**PRODUCT SAFETY ADVISORY****Notice of Potential Unsafe Condition**

**AADvance Workbench, AAdvantage-Trusted SIS Workstation,  
ISaGRAF, Trusted Toolset, and FlexiSafe  
Reset Coil Order of Execution**

Reference: 2020-08-002

Date: August 2020

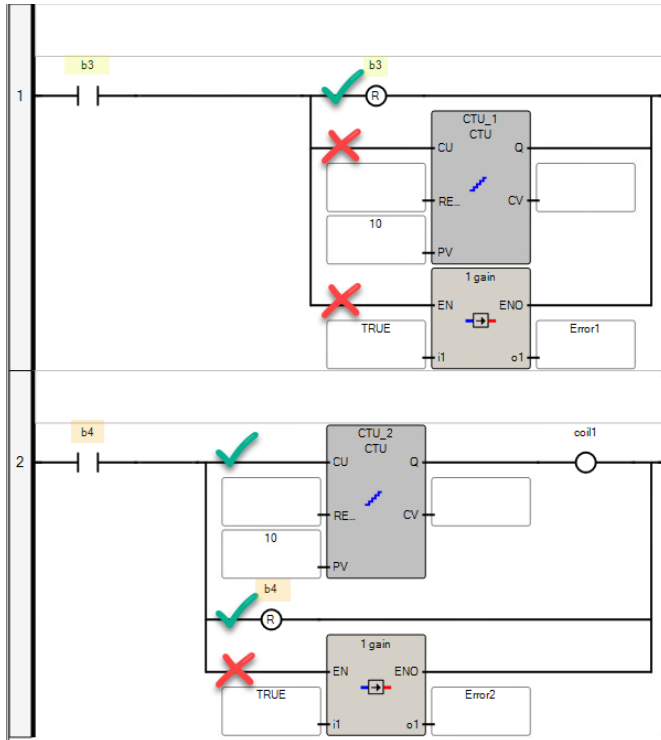
The example at the left shows two possible conditions affected by this anomaly. In the first example rung, the Reset coil is placed first in the branch. Operations placed after the Reset coil will not execute, as shown identified by the red X.

In the second example rung, the Reset coil is placed in the middle of the branch. Operations placed before the Reset coil will execute, as shown by the green checkmark. However, operations placed after the branch will not execute, as shown by the red X.

Customers are advised to review all ladder logic where Reset coils are used and verify the Reset coil operation is placed last in the branch operations.

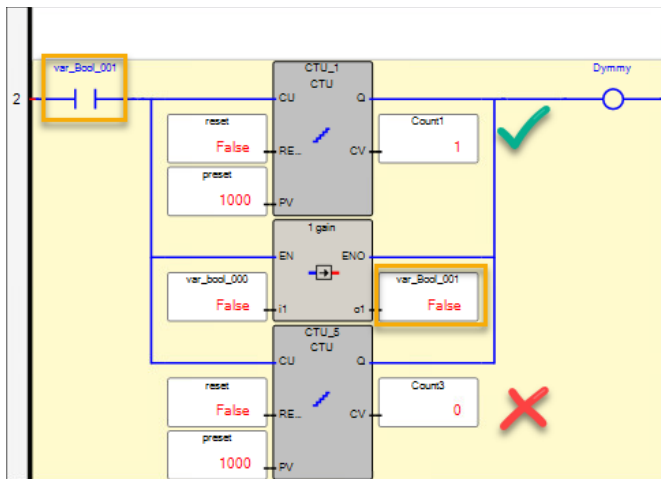
Further, the example at the left shows a configuration where the use of the Reset coil with multiple branches results in rung operations in subsequent branches not executing.

When using ladder logic programming (not ladder elements in the FB Editor), if a contact is used to activate many branches within the same rung AND the state of this contact is changed before the last branch of the rung, then subsequent branches of the same rung will not execute.
